Subject: FW: 16-20 High Road, N22 6BX

I write to acknowledge your email dated 24th April 2019 and The Licensing Authority's representation in relation to application for a variation to Tarshish 12 High Road, Wood Green, London N22 6BX.

<p>CC_003</p>	<p>16-20 High Road Wood Green London N22 6BX</p>	<p>DATE 24/04/19</p> <p>CHECKED BY PC</p> <p>DRAWN BY NK</p>	<p>PROJECT Third floor Extension</p> <p>PROJECT NO. 1901713</p>	<p>CLIENT Tershih Restaurant</p>	<p>DOMUS Architectural & Project Management 16-20 High Road Wood Green London N22 6BX 020 8144 2898</p>
	<p>Approved for construction 24/04/19 PC</p>

01 Proposed Roof Plan (electrical layout)
 SCALE 1:100 @ A3

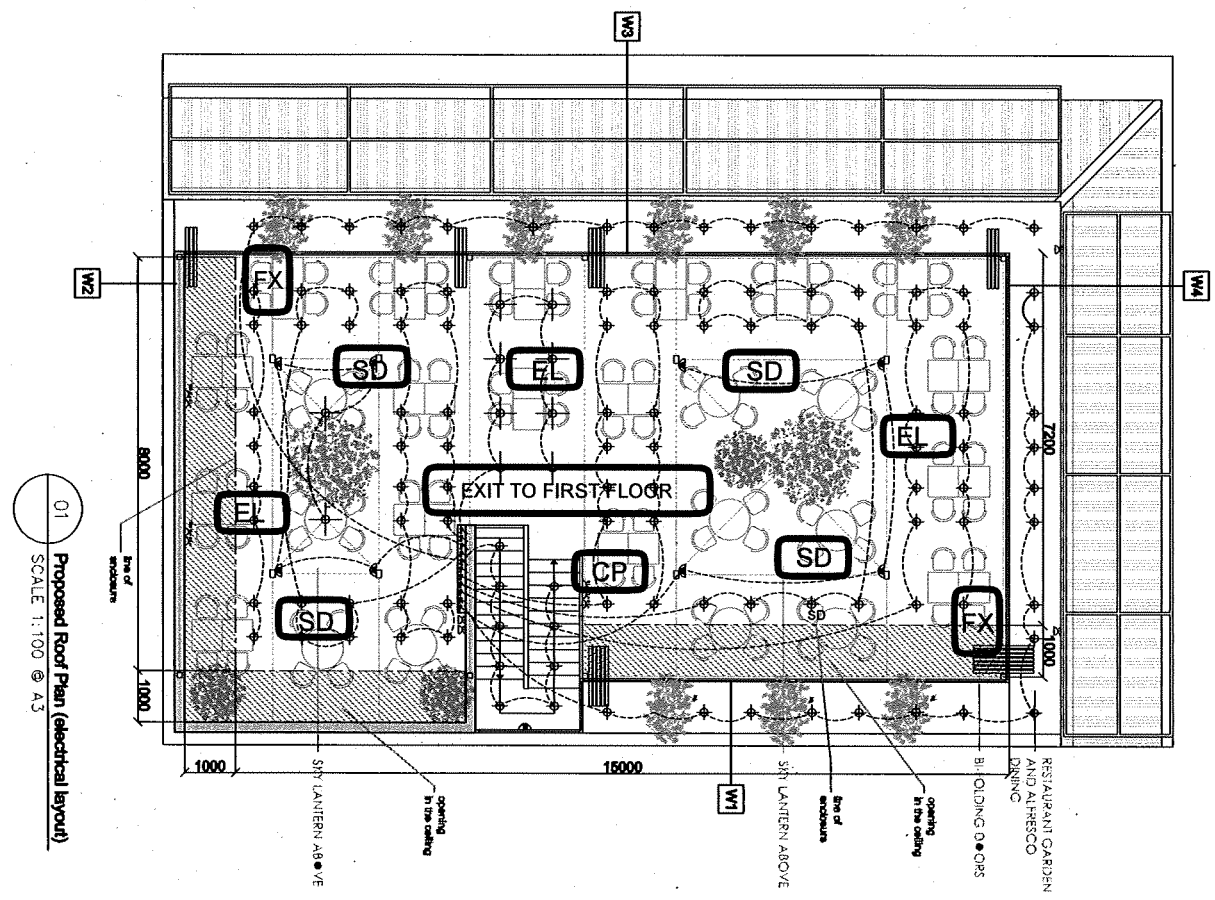
1. *The stairs on the roof plan do not line up with the stairs on the second floor*
2. *No accommodation numbers provided.*
3. *No Call Points shown at Storey exit.*
4. *No emergency lighting shown.*
5. *No exit signage indicated on plan.*
6. *No fire alarm provision indicated.*
7. *Electrical circuits not demonstrated to be fire resisting.*
8. *Electrical circuits not shown to be provided with RCD protection.*
9. *Staircase and balustrading details not provided.*
10. *Provision for disabled not indicated.*

The stairs on the roof plan do not line up with the stairs on the second floor

No Call Points shown at Storey exit.

No emergency lighting shown.

No exit signage indicated on plan.

No fire alarm provision indicated.

Electrical circuits not shown to be provided with RCD protection.

Attached here is a clarified drawing showing how the relevant stairs line up. We trust this will address the concern raised. (Attachment 1)

We anticipate the maximum number of patrons on the proposed 3rd floor to be 70.

Call Points are clearly addressed please check (Attachment 1)

Emergency Lighting is clearly highlighted please see (Attachment 1)

Exit signage is clearly indicated, please see (Attachment 1)

Exit signage is clearly indicated, please see (Attachment 1)

**Electrical circuits are shown on (Attachment 1) but not yet detailed.
You will find this written and displayed on (Attachment 1).
Once detailed will be presented to Local Authority.**
